ADDENDUM ONE

Terhune Ground Floor and First Floor Bookstore Renovations
H59-6288-JM

DATE : July 28, 2025

PROJECT : 3202-240135

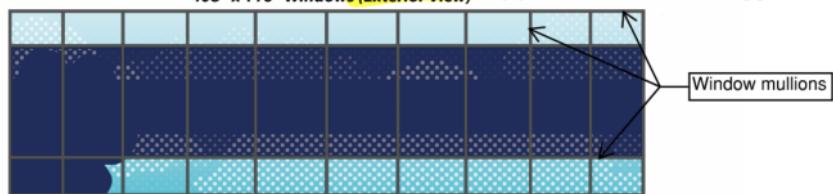
6. There is no hazardous report on file. The Terhune building was constructed in 2002 and is assumed to be clear of hazardous materials – verification and removal of any hazardous material is the Owner's responsibility. Refer to Article 10.3 in the AIA A201 OSE Version.
